PARK PLACE AT WESTCHESTER AIRPORT

Draft Supplemental Environmental Impact Statement

DRAFT SUPPLEMENTAL ENVIRONMENTAL IMPACT STATEMENT

March 22, 2016

C-13

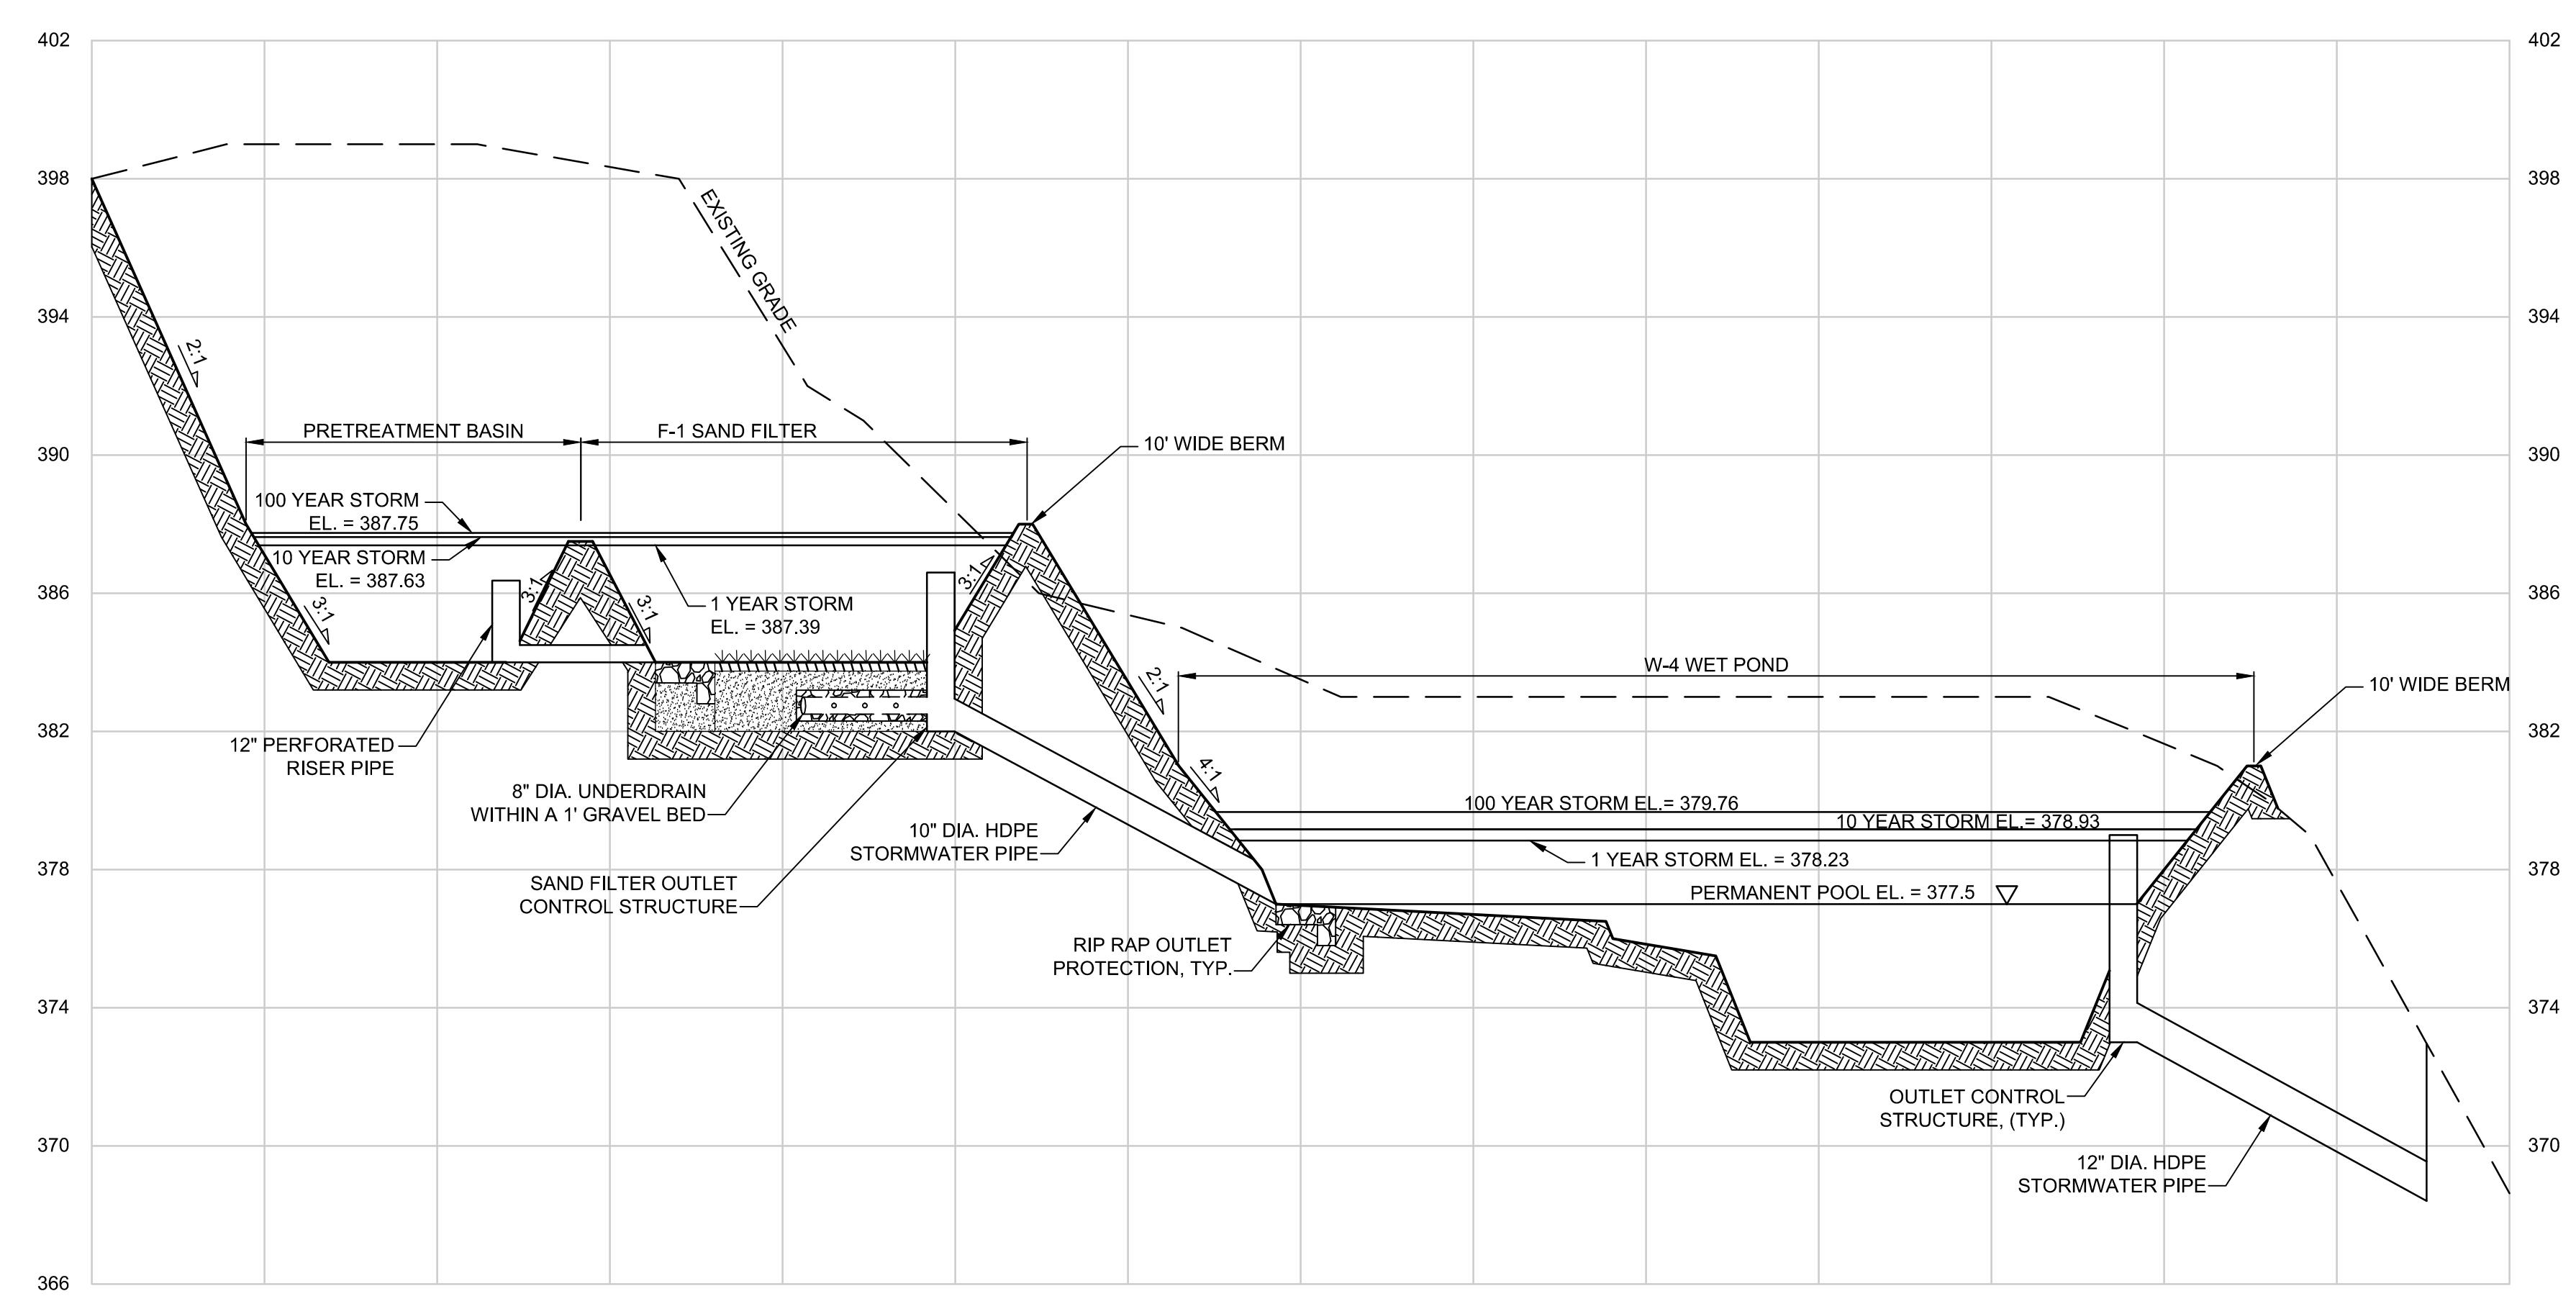
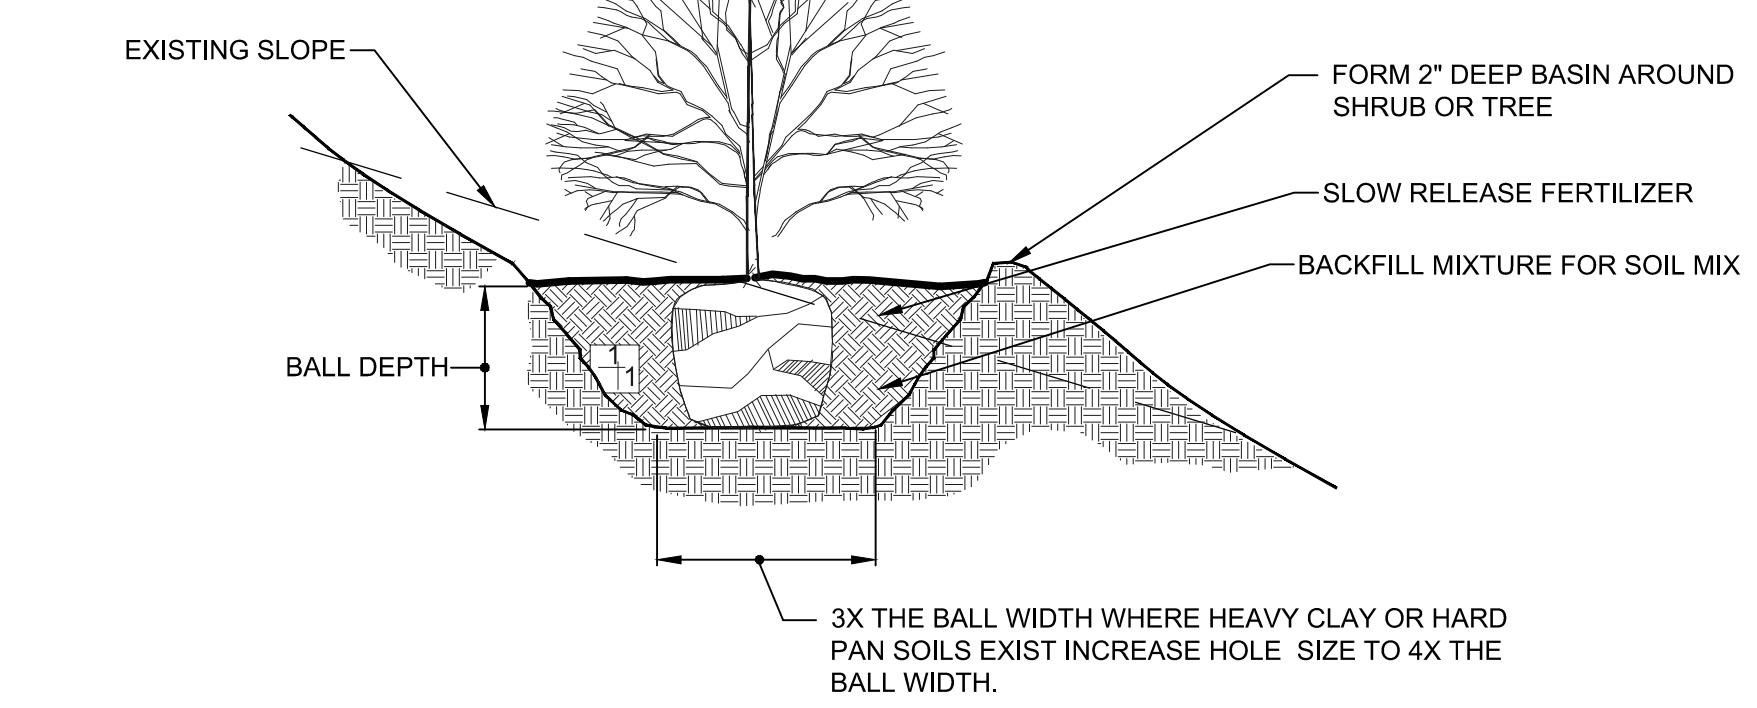
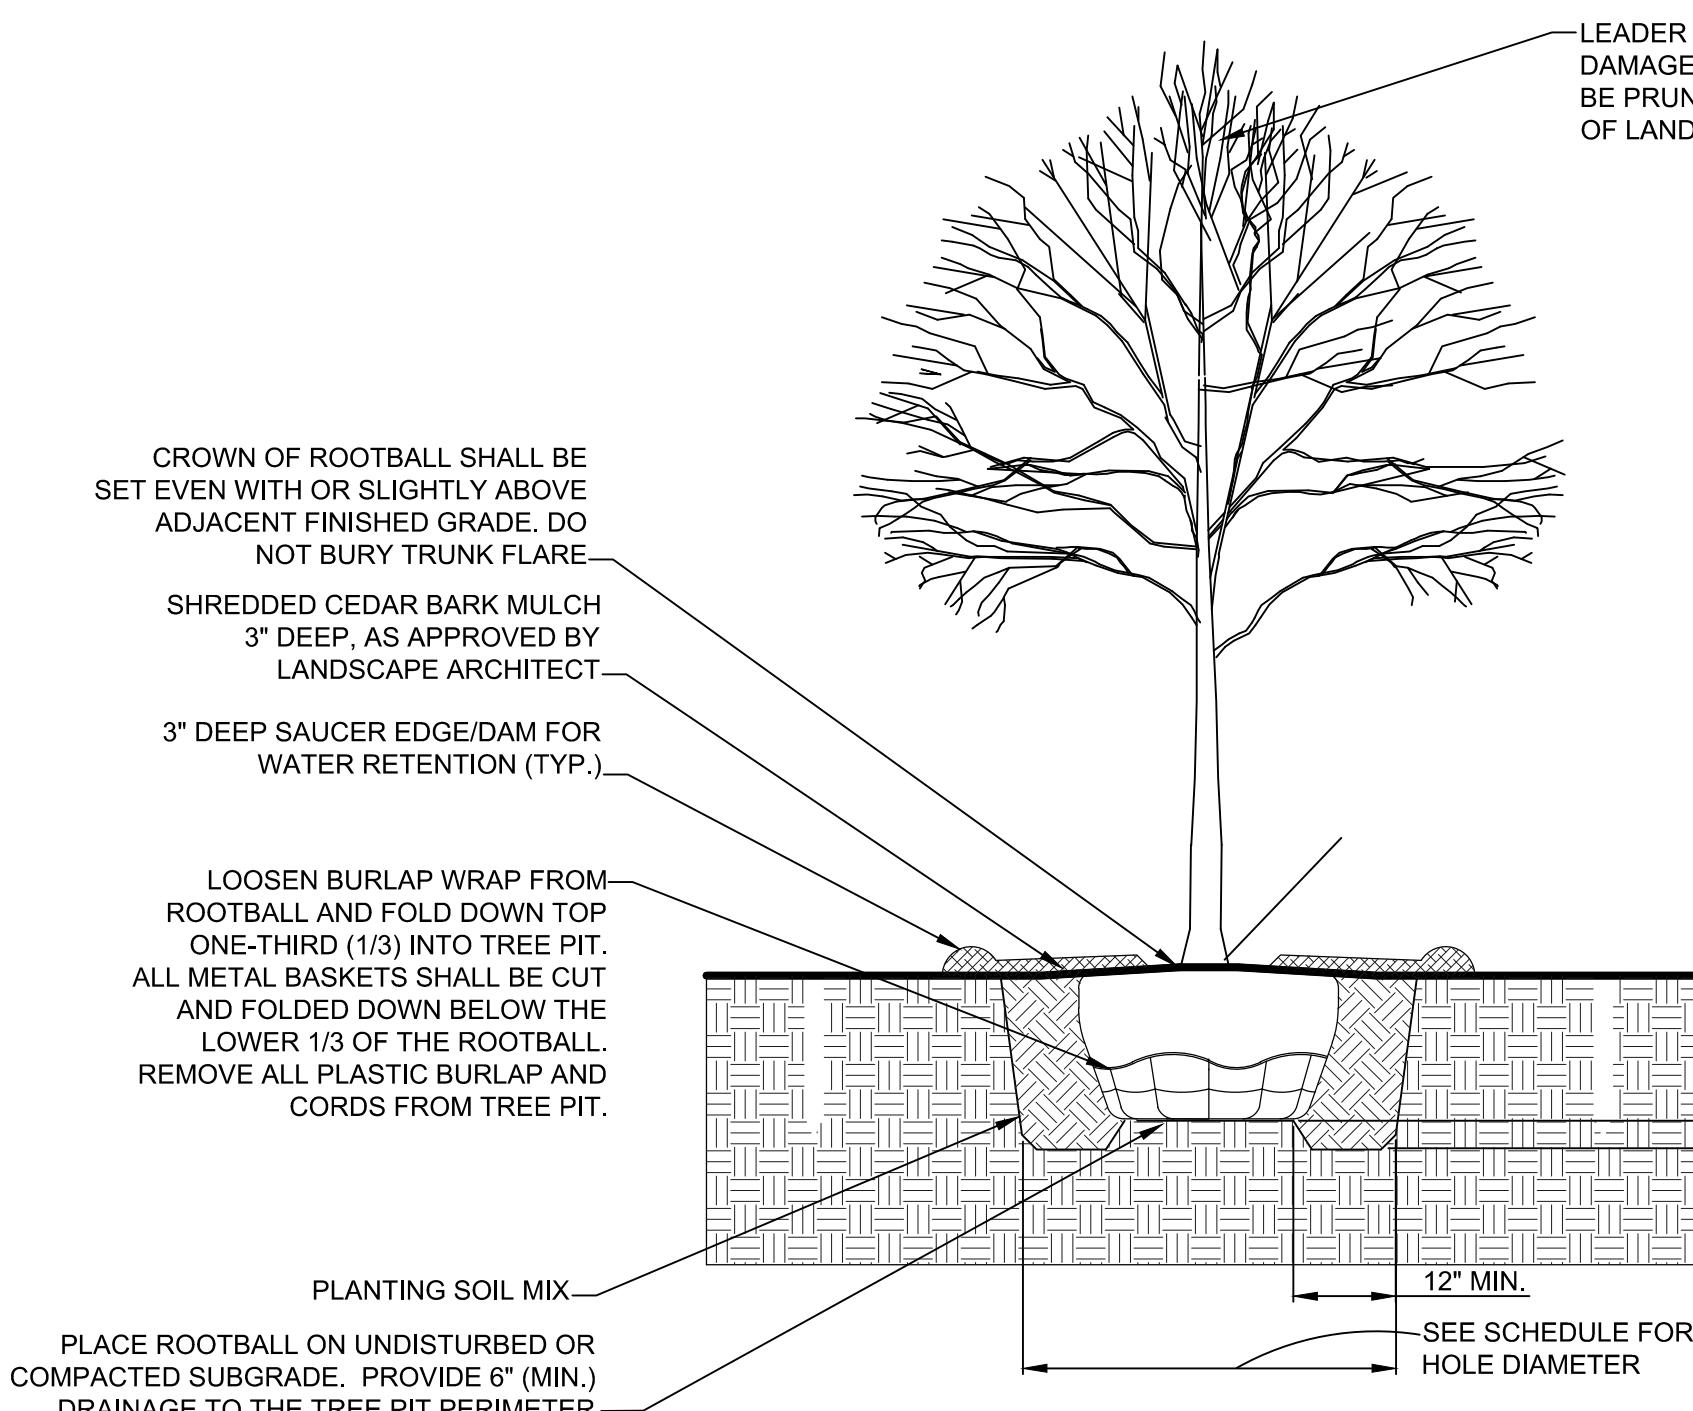
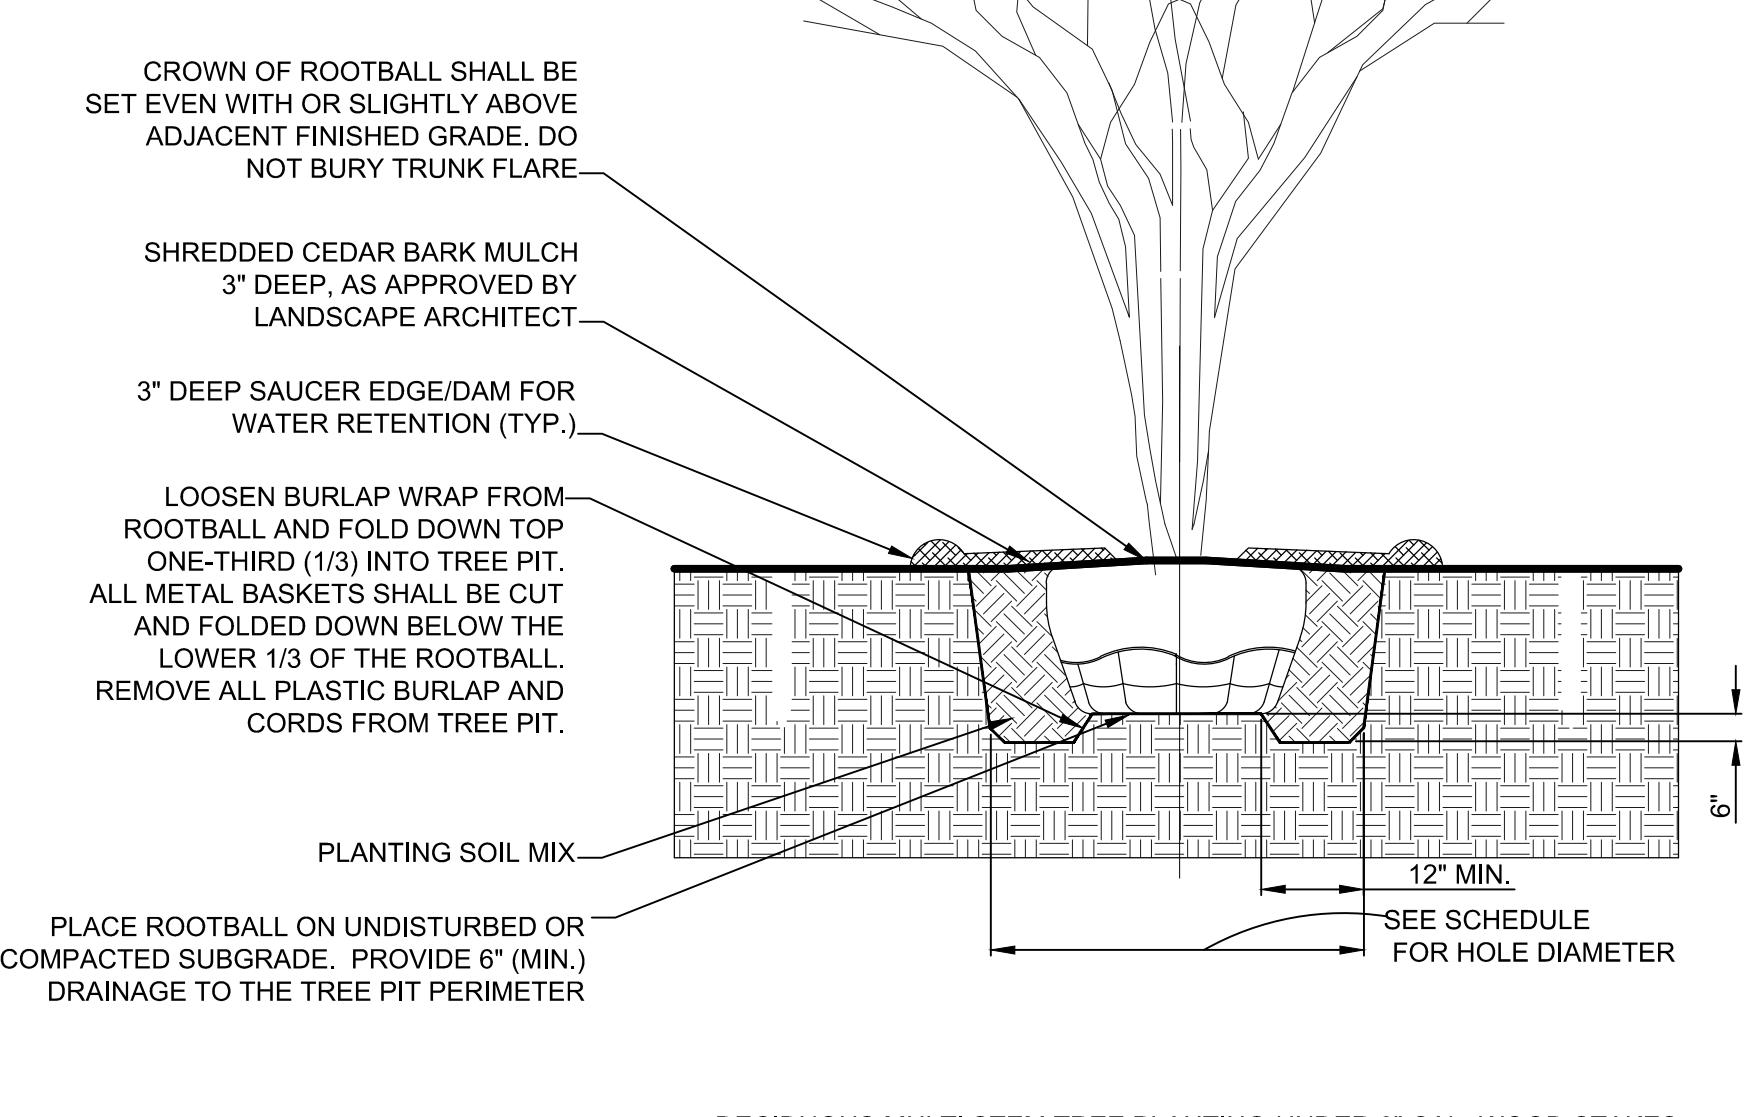
Comment 15: Drawing C-13 shows planting details for deciduous and evergreen trees, and deciduous shrubs on steep slopes. Note that the use of stakes, guy wires, and tree wrap is no longer considered to be standard practice and should only be used where trees are subject to high winds (for guying materials) and thin-barked trees to sun-scale (for tree wrap). Should the site have these conditions and use of these items is necessary, a note on the plan should then be added to require their removal prior to final acceptance (i.e., within 1 year following planting) of the landscaping. If these materials are left in place, there is a shigh likelihood they will eventually strangle the trees and/or harbor pests or diseases and cause mortality. (NYCDEP 2/12/15)

Comment 20: The data presented in the Stormwater Facility Profile shown on drawing C-13, Standard Details IV, is incorrect and does not agree with the current HydroCAD routing inputs and results. In addition, drawing C-13 shows the wetland permanent pool to be at elevation 377.5, while the HydroCAD routings start at pool elevation 378.00. The wetland outlet pipe elevation should be 372.5, instead of 368.5+/- shown on the drawing. Therefore, the entire Stormwater Facility Profile should be re-drawn once the correct elevations and dimensions have been established. (Office of the Watershed Inspector General, 2/19/15)

16. Drawing C-13 shows planting details for deciduous and evergreen trees, and deciduous shrubs on steep slopes. Note that the use of stakes, guy wires, and tree wrap is no longer considered to be standard practice and should only be used where trees are subject to high winds (for guying materials) and thin-barked trees to sun-scald (for tree wrap). Should the site have these conditions and use of these items is necessary, a note on the plan should then be added to require their removal prior to final acceptance (i.e., within 1 year following planting) of the landscaping. If these materials are left in place, there is a high likelihood they will eventually strangle the trees and/or harbor pests or diseases and cause mortality.

- a. The data presented in the Stormwater Facility Profile shown on drawing C-13, Standard Details IV, is incorrect and does not agree with the current HydroCAD routing inputs and results. The following table illustrates the inconsistencies between drawing C-13 and the HydroCAD values:

In addition, drawing C-13 shows the wetland permanent pool to be at elevation 377.5, while the HydroCAD routings start at pool elevation 378.00. The wetland outlet pipe elevation should be 372.5, instead of the 368.5 +/- shown on the drawing. Therefore, the entire Stormwater Facility Profile should be re-drawn once the correct elevations and dimensions have been established.

Response: Comment noted. The planting details on Drawing C-13 have been revised and the following note has been added to the Landscape Plan, Drawing C-9:
